3365 VI. CALORIMETRY

3407 B. ECAL/HCAL electronics upgrade: analogue front-end

3474
 3475 FIG. 89. Super common base amplifier with current feedback (left) and interleaved switched paths
 3476 (right).

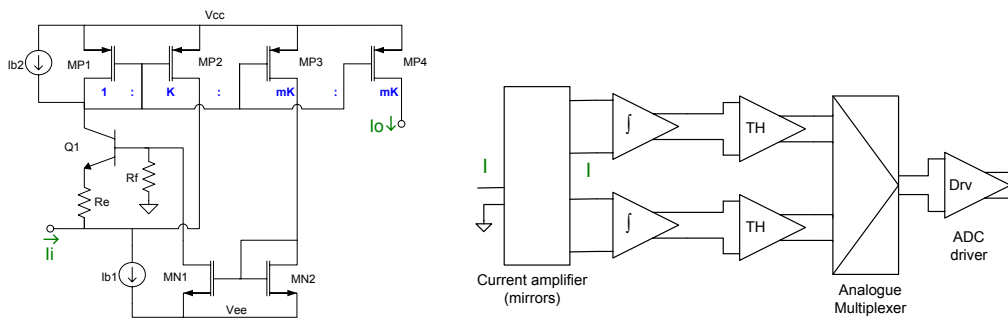
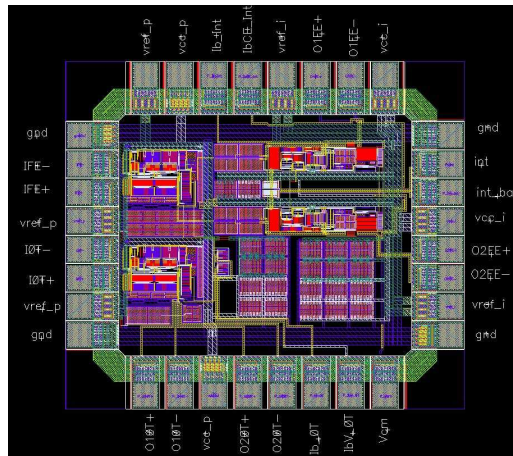
- Number: 9 Author: rlindner Subject: Sticky Note Date: 31/01/2011 10:15:04
3462-3464
reasons for the innovations?
Is the current mirror output really an innovation or just a simple change?

**Changes that improve the system but requires some tests. Innovation kept.
(innovation: second current feedback to set 50 ohm input impedance)**

FIG. 91. Principles of Operation for COTS solution.

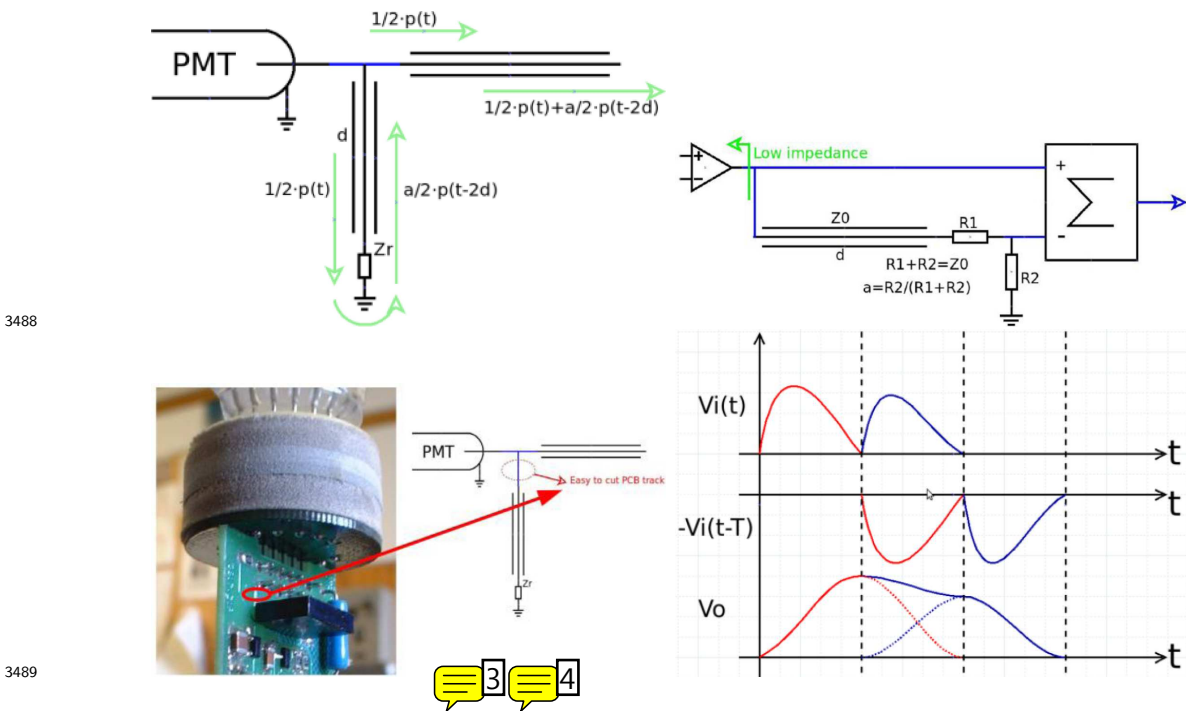
- Number: 3 Author: rlindner Subject: Sticky Note Date: 31/01/2011 10:40:06
Figure 91: (Ueli)
Figure Caption: Please add some figure caption text, which **caption modified**
explains the figure.
Also: the way it is drawn, one would expect a negative signal at the **The negative signals are opposite
third sampling point. Explain why this is irrelevant (the grade of sign copies of the real signal.
irrelevance depends possibly on the channel occupancy) Permits to reset the integrator,
but full integration is ≥ 0 .**
-

- Number: 4 Author: rlindner Subject: Sticky Note Date: 31/01/2011 10:40:00
Fig 91/92(Ueli)
I would suggest to combine Fig 91 and 92 into one single figure. **Done. 92 is removed.**
-

FIG. 93. One front-end block of 8 channels.

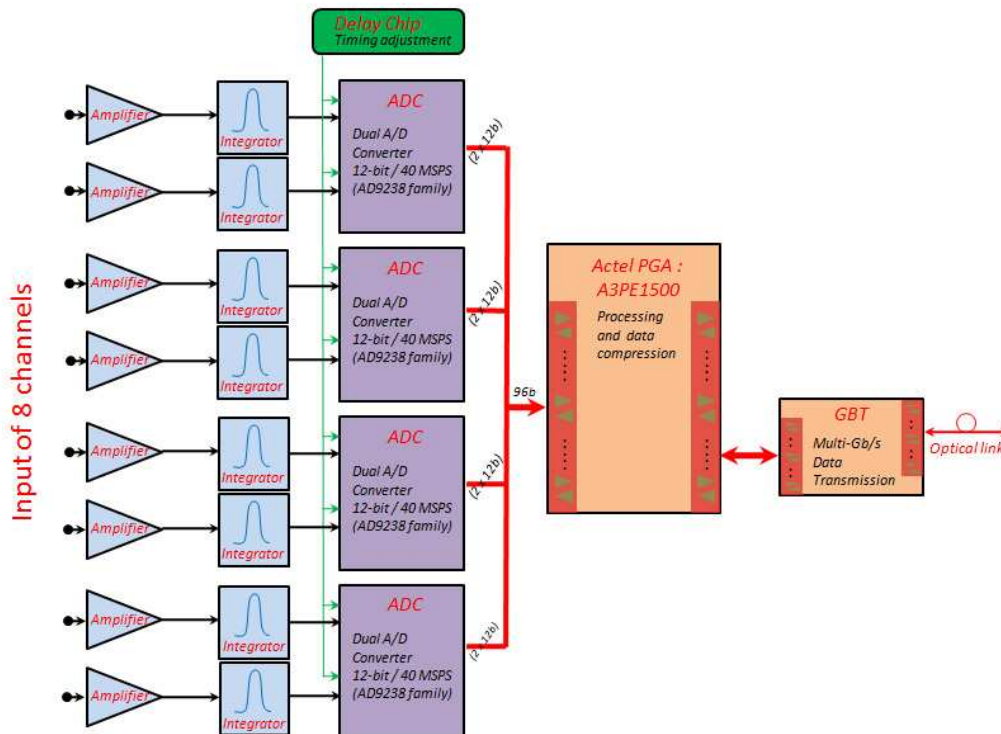
-  Number: 2 Author: rlindner Subject: Sticky Note Date: 31/01/2011 10:40:48
3531(4)?: (Ueli)
use correct section reference
-
-  Number: 3 Author: rlindner Subject: Sticky Note Date: 31/01/2011 09:58:01
3537(Ken)
This line should be at the end of the previous paragraph, I think? [Done](#)
Change figure reference.. There is no figure VIC !
-

-  Number: 4 Author: rlindner Subject: Sticky Note Date: 31/01/2011 10:40:53
remove line 3537 (Ueli)
and add a reference for figure 93 to line 3529. [Done](#)
-

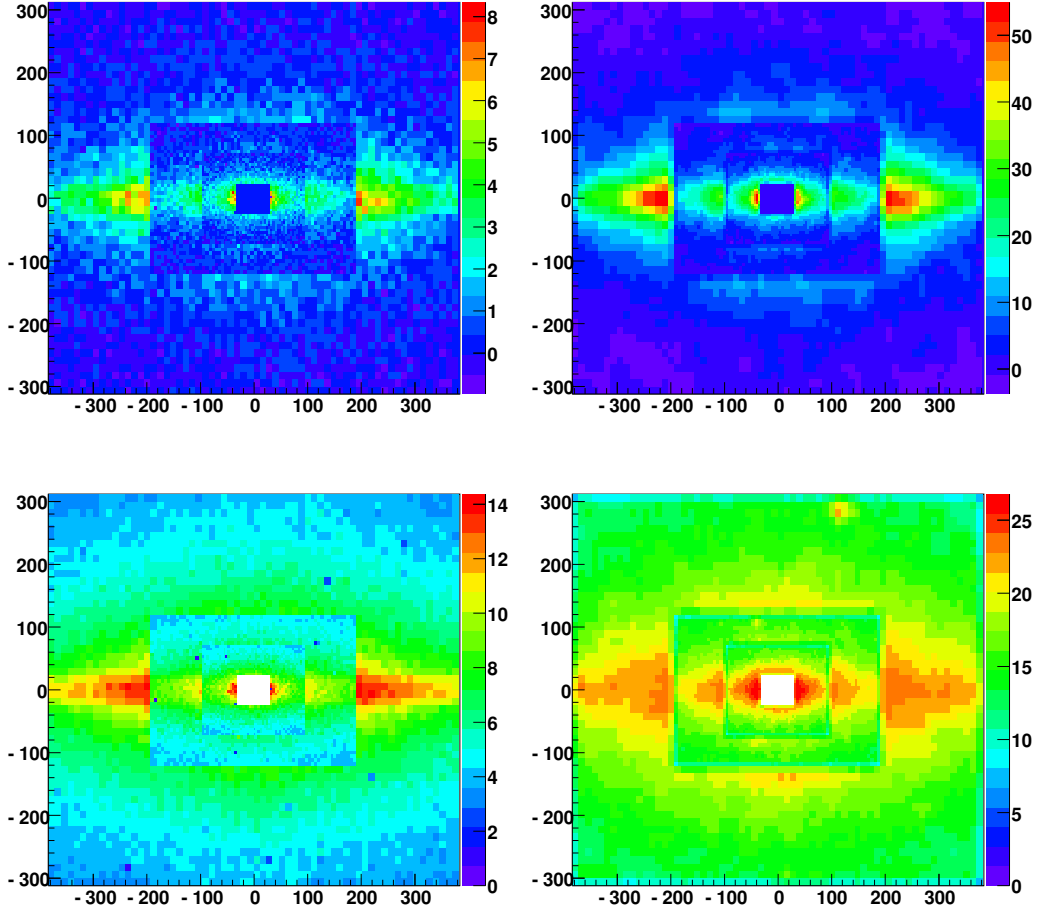
figure caption: Please give some indication, what this means in terms of energy.

Measures the Pt fluctuations on the calorimeter surface. Caption modified to give the information.
